## ALADDIN SHRINE CENTER

CITY OF GROVE CITY, FRANKLIN COUNTY, OHIO  
**FINAL DEVELOPMENT PLAN**  
FOR  
**ALADDIN SHRINE CENTER**  
TITLE SHEET

RE: Aladdin Shrine Center – 1801 Gateway Circle  
Final Development Plan Resubmittal  
Application Control Number #201501050002

With this letter we are resubmitting the Final Development Plan for the Aladdin Shrine Center. We have reviewed the comments provided in your letter dated January 16, 2015, and offer the following responses for your consideration:

SHEET 1 / 1

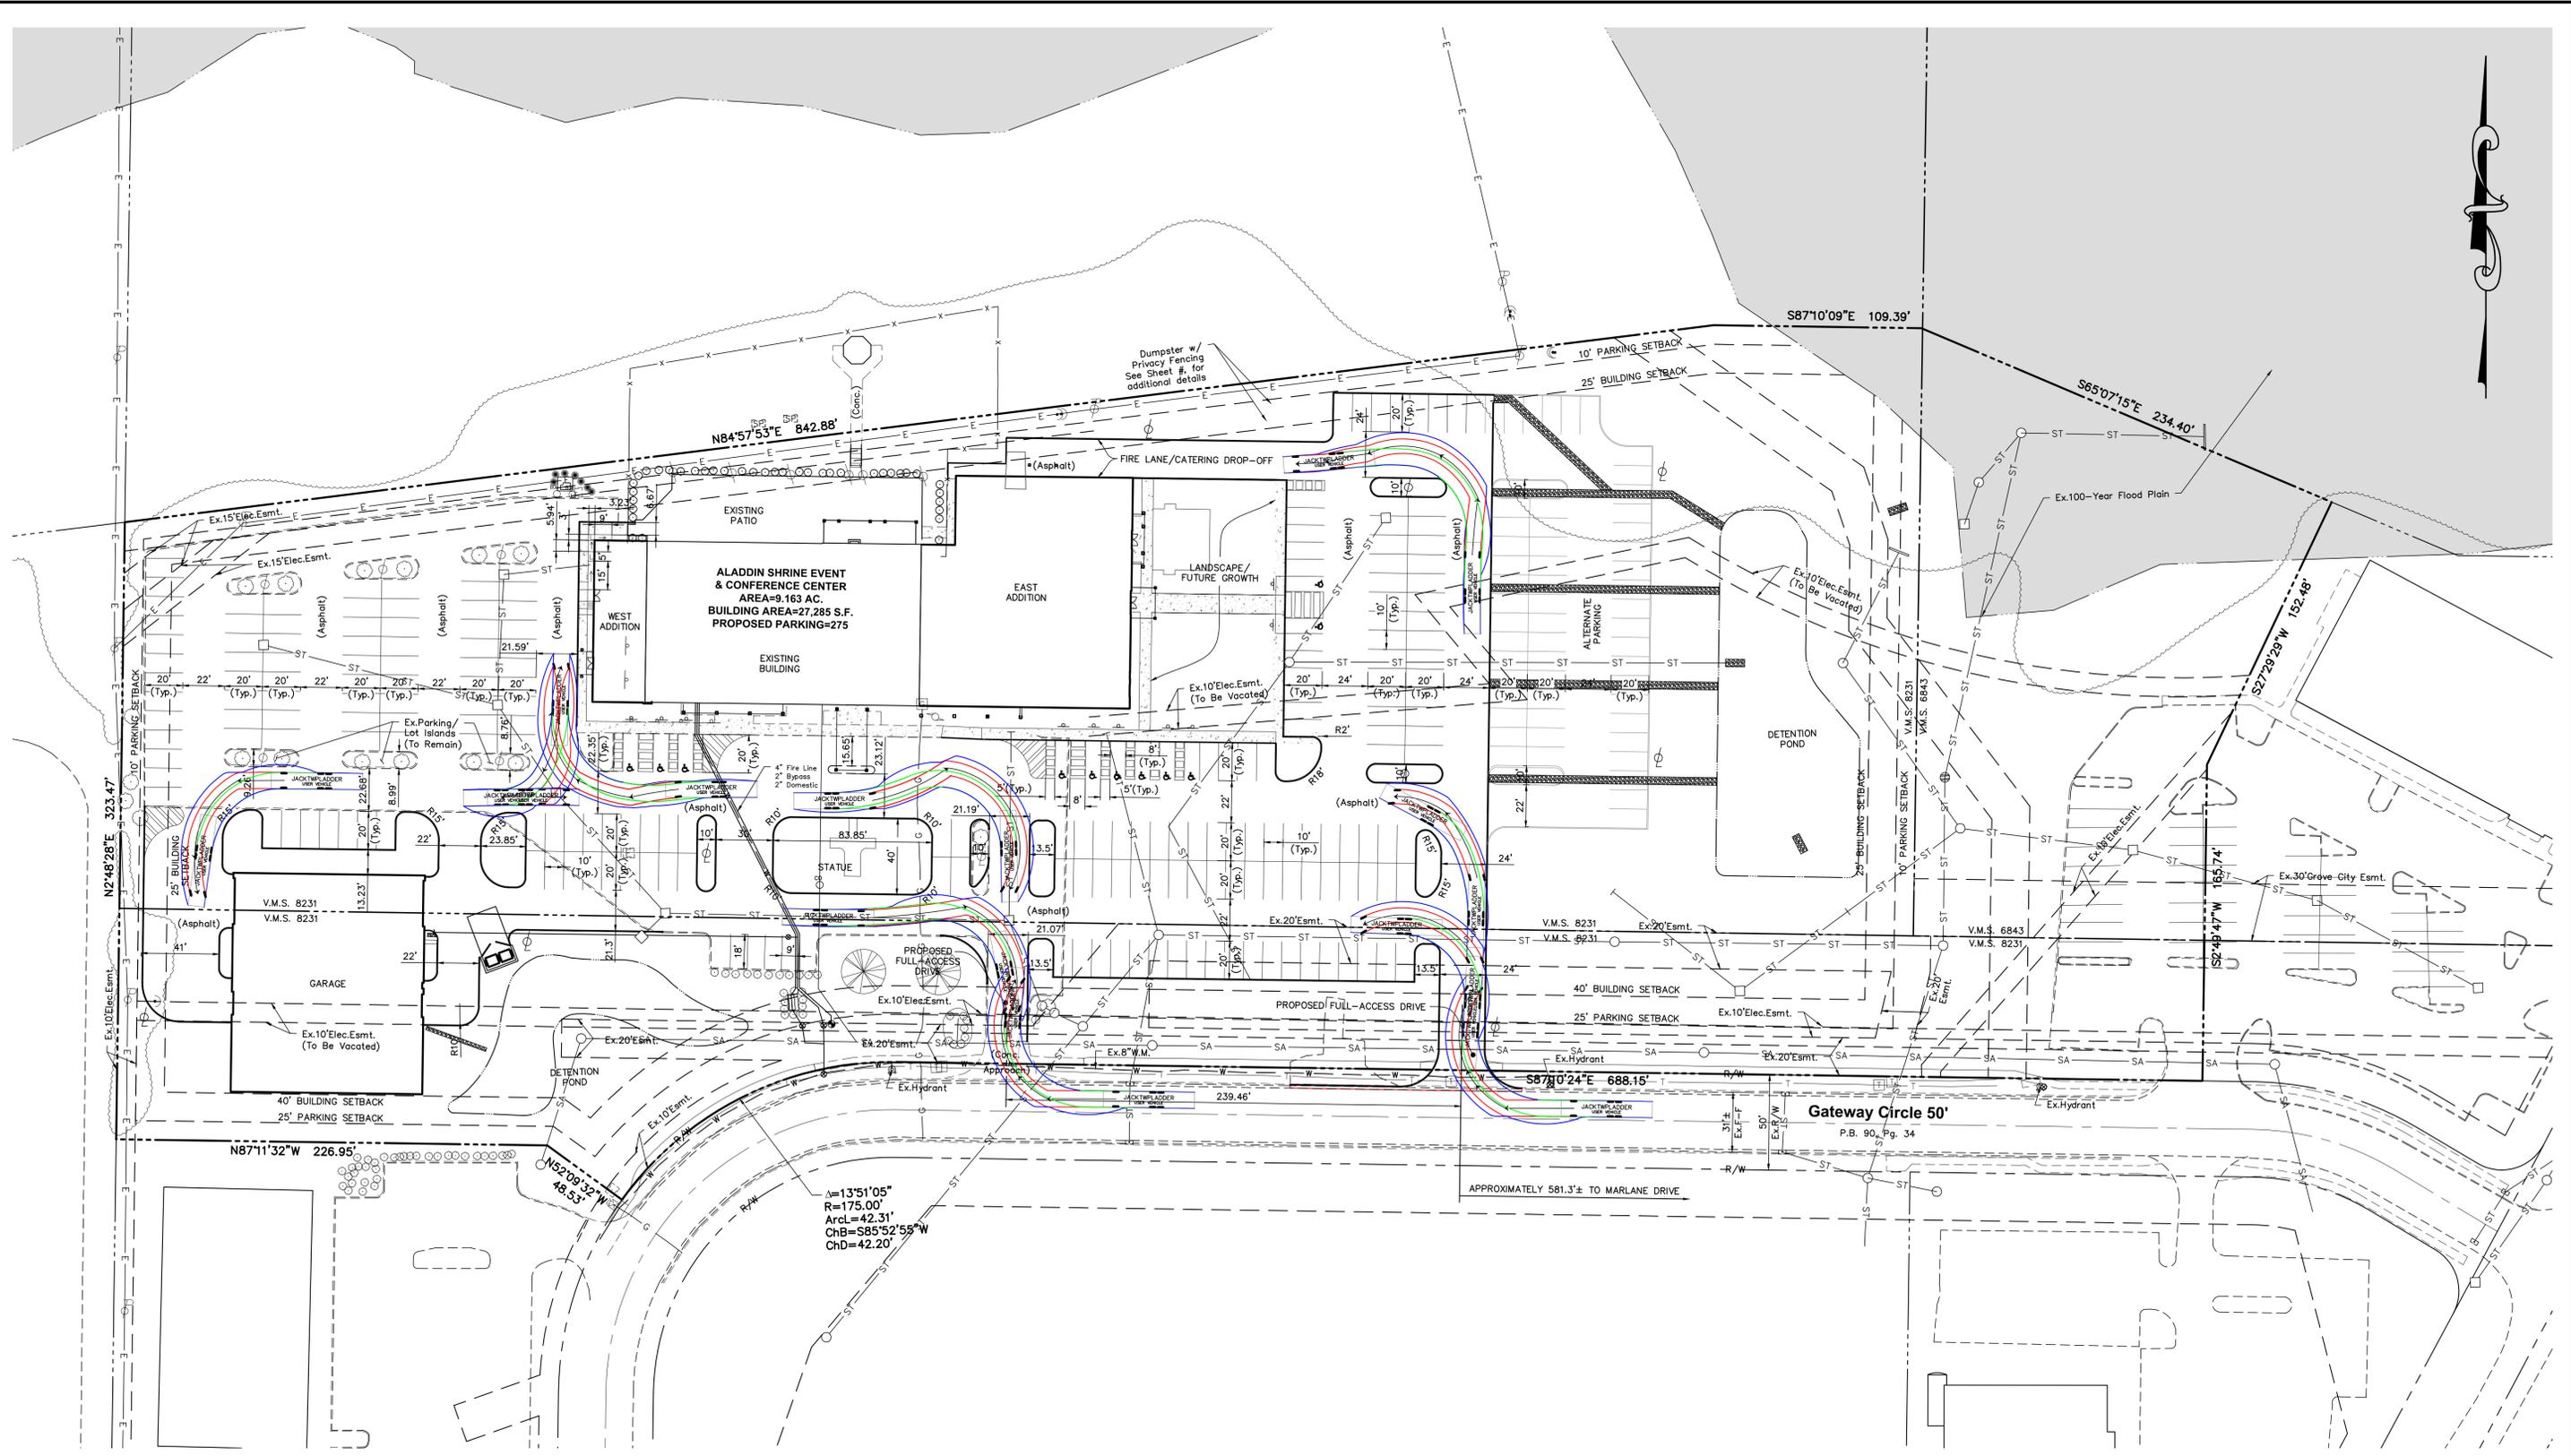
35. Please show the ladder truck maneuverability in the parking lot. *(See attached Apparatus Reference Guide)*
